Access Compliance Report Public Rights-of-Way (Curb Ramps)

Intersection ID: 11690Main Street: AIRLIE_STCross Street: JEFF_STLocation:SEADA ID: BEED82B455E4Ramp Type: BlendTrans1Initial Pass/Fail: FailOverall Compliance: NoSeverity Score: 8.75

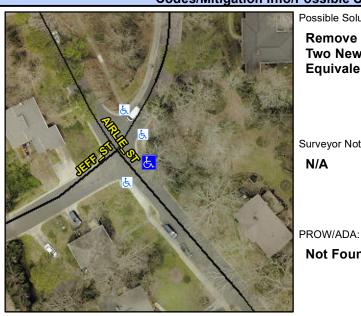
Not Found, R304.5.1

Field Measurements/Component Compliance					
Compliance Description		Data	Comp	liance Description	Data
N/A	Ramp Length (in)	48.0	Yes	BlendTrans Slope (%)	2.6
No	Ramp Width (in)	47.5	Yes	BlendTrans XSlope (%)	2.0
N/A	Flare Type LT	N/A	N/A	Flare Type RT	N/A
N/A	Flare Slope LT (%)	N/A	N/A	Flare Slope RT (%)	N/A
N/A	Flare Traversable LT?	N/A	N/A	Flare Traversable RT?	N/A
N/A	Landing Length (in)	N/A	N/A	DWS Provided?	N/A
N/A	Landing Width (in)	N/A	N/A	DWS Contrast?	N/A
N/A	Landing Slope (%)	N/A	N/A	DWS Length (in)	N/A
N/A	Landing X Slope (%)	N/A	N/A	DWS Full Width?	N/A
N/A	Landing Curb? (Y/N)	N/A	N/A	DWS Offset (in)	N/A
N/A	Shared Landing?	N/A			
N/A	Gutter Ponding?	N/A	N/A	Gutter Slope (%)	N/A
N/A	Gutter Lip Ht (in)	N/A	N/A	Gutter X Slope (%)	N/A
N/A	Painted X Walk1?	No	N/A	Painted X Walk2?	N/A
	X Walk 1 Direction	To SW		X Walk 2 Direction	N/A
	X Walk 1 Width (in)	N/A		X Walk 2 Width (in)	N/A
	X Walk 1 Slope (%)	4.0		X Walk 2 Slope (%)	N/A

X Walk 1 X Slope (%)	2.5		X Walk 2 X Slope (%)	N/A
N/A	Ramp inside XWalk1?	N/A	N/A	Ramp inside XWalk2?	N/A
	Road Slope (%)	2.5		Clear Space?	N/A
	Road X Slope (%)	4.0	N/A	Clear Space to XWalk (in)	N/A
N/A	Any Obstructions?	N/A	N/A	Storm Grate/Utility Hazard?	N/A
	Obstruction Type			Storm Grate/Utility Type	
		N/A			N/A
			Yes	Surface Condition? (G/P)	Good
			No	Curb Slope (%)	19.8

Remove & Replace Curb Ramp With
Two New Directional Ramps or
Equivalent.
